**DATE:** May 18, 2011

**SUBJECT:** Addendum No. 3

**PROJECT NAME:** **DIGITAL SIGNAGE, MENU BOARDS & INSTALLATION**

**JJC PROJECT NO.:** B11033

DRAWN BY:	JDS
DETAILS	
DWG NO.	101
DATE:	2/9/2011

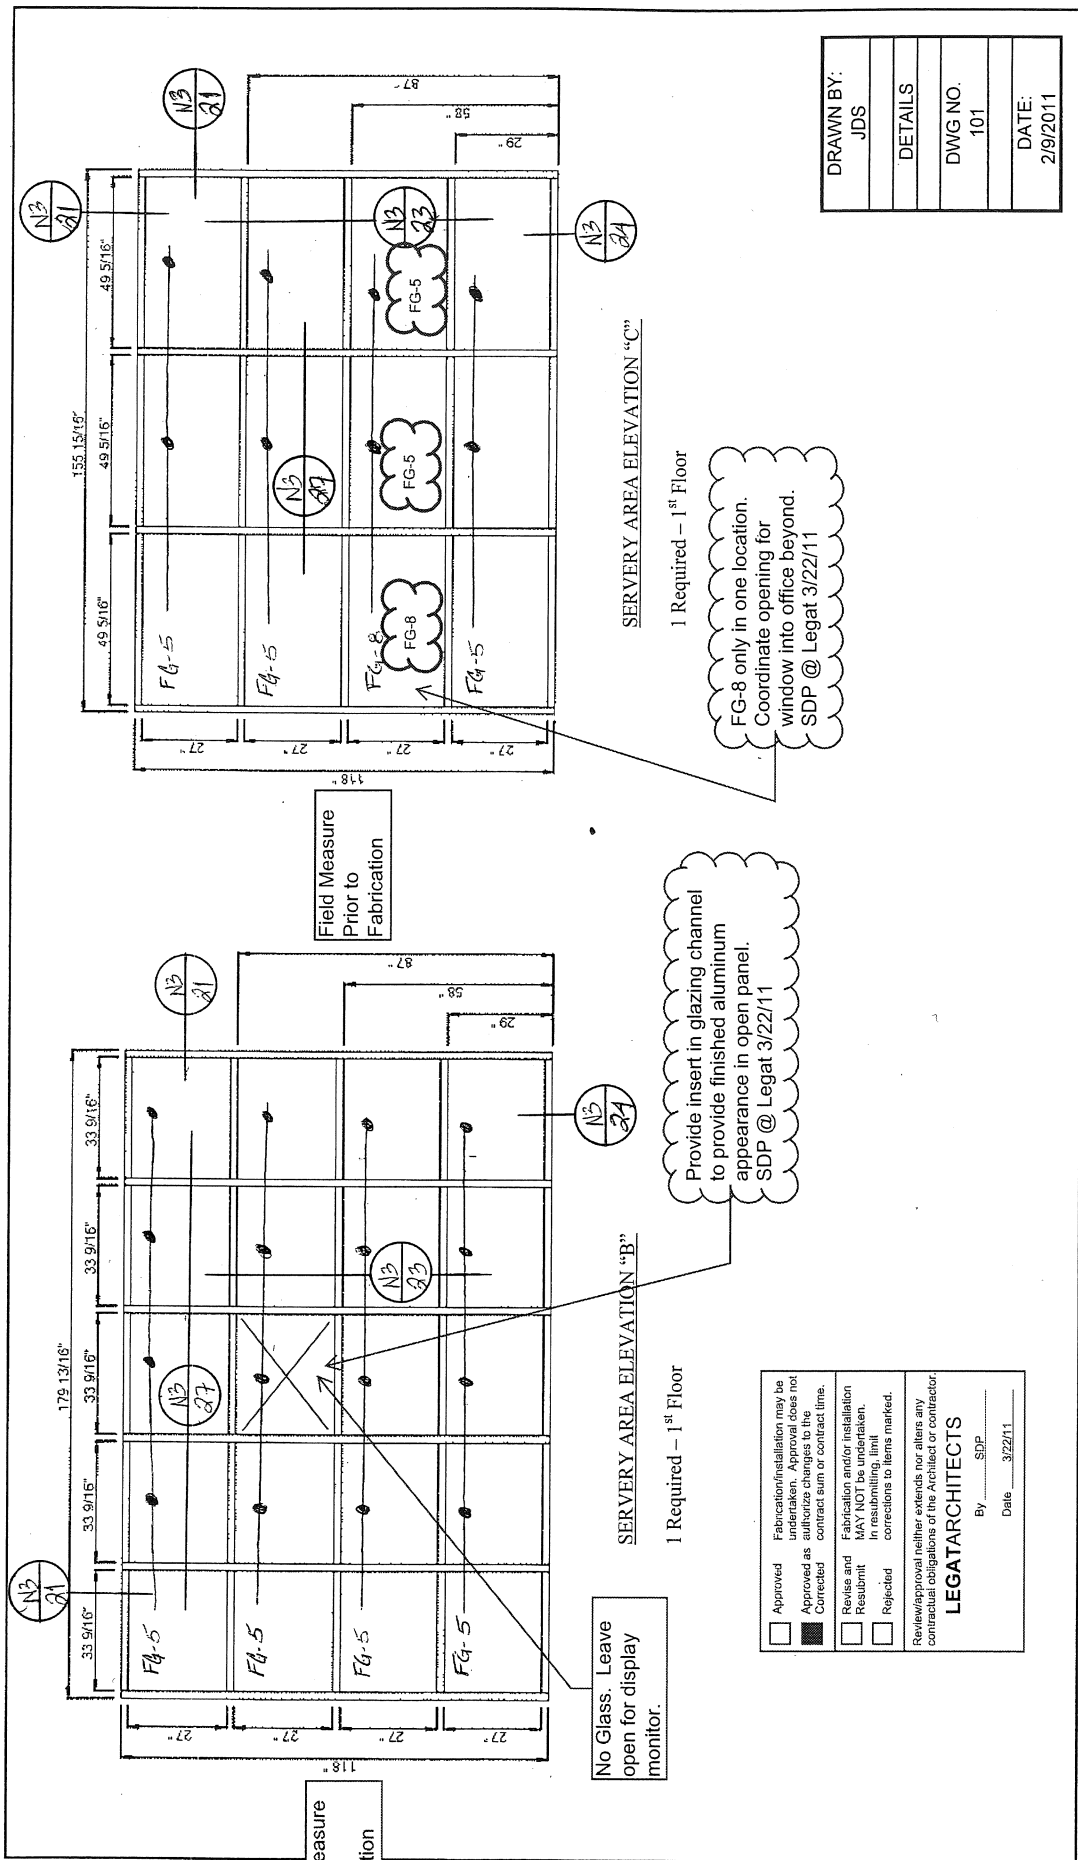
1. Provide the aluminum frame opening size.

Provide insert in glazing channel  
to provide finished aluminum  
appearance in open panel.  
SDP @ Legat 3/22/11

FG-8 only in one location.  
Coordinate opening for  
window into office beyond.  
SDP @ Legat 3/22/11

***The aluminum frame opening size is 27" x 9/16". Please refer to attached drawing.***
